From: David Gower
Sent: 12 August 2021 12:57
To: Erica Buchanan
Subject: RE: Coventry Stadium Rugby Road R18-0186

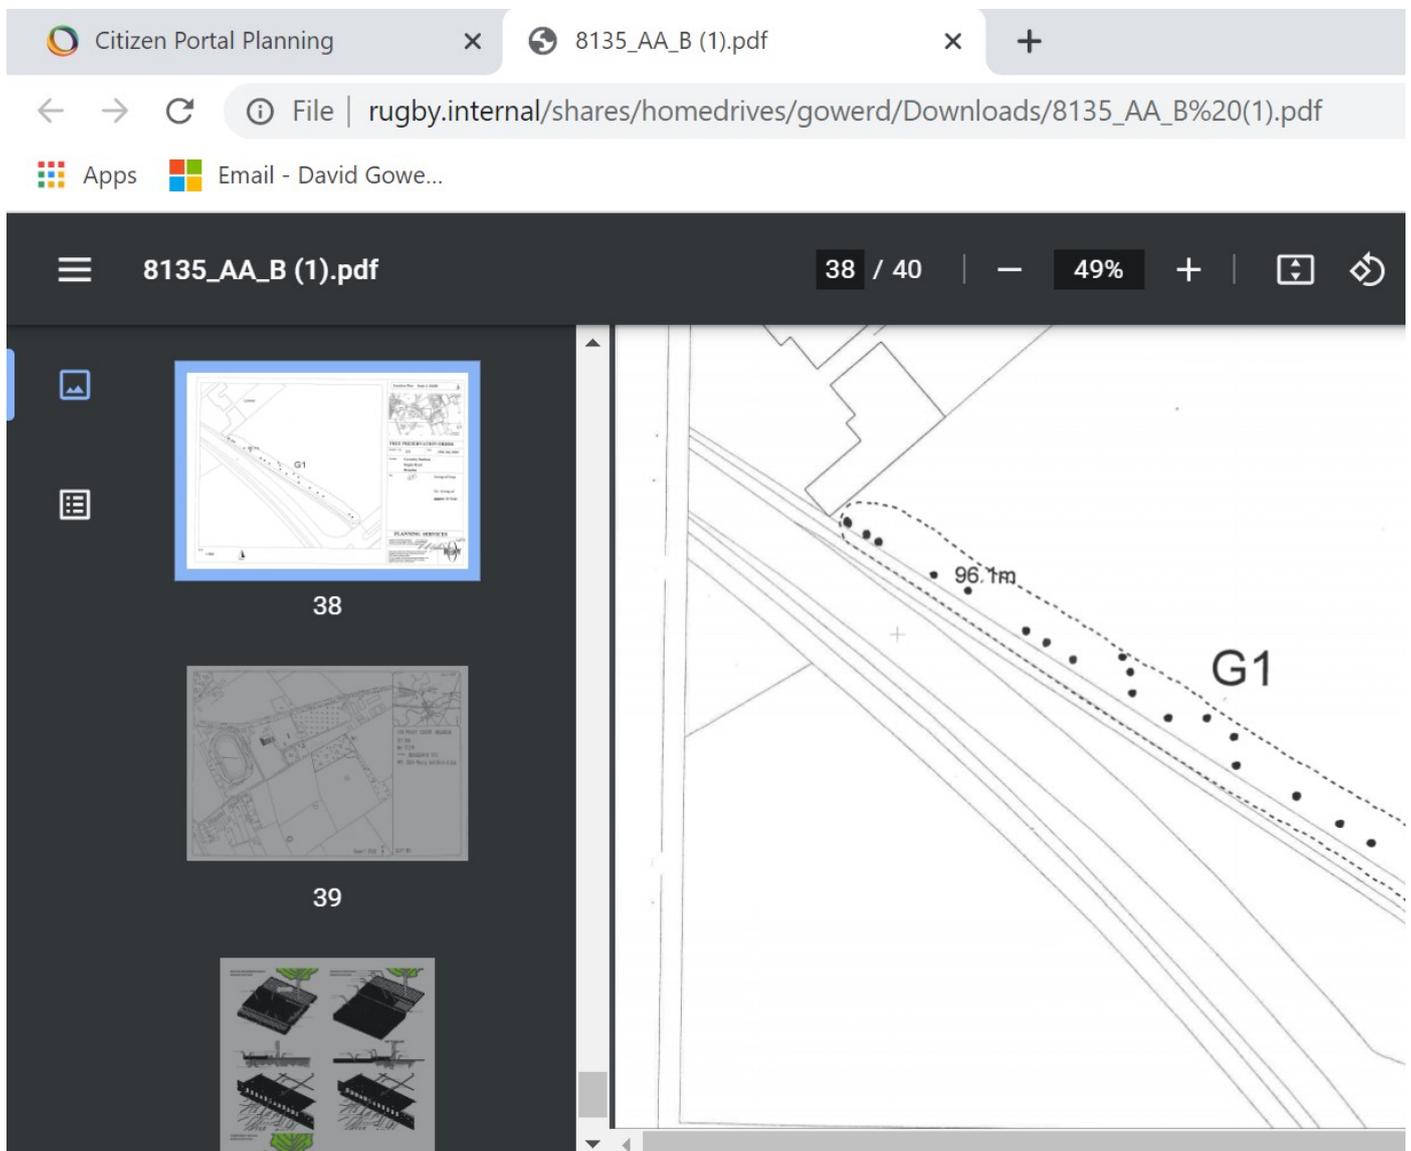
I had another look on site on Tuesday and as per previous comments there would be an major impact on that row of TPO Oak trees. One of the Oaks especially is the biggest and most prominent out of the group.

There is actually an existing gap (where a disused utility pylon is) to the south east of the proposed entrance and as shown in the TPO plan below (approx. 20 metres wide). Has that been considered for access?

Elsewhere and to the north western boundary near to where the football pitch is proposed a small area of tree removal is proposed. This is outside of the TPO tree group and consists mainly of young Poplar/Birch/Elder scrub. I have no objection to this but would object to the loss of mature TPO tree cover to form the new access and as per previous comments.

Yes they did and initially they were looking at an alternative place for the access but I think there would have been an issue with Highways which is why the access stayed the same.
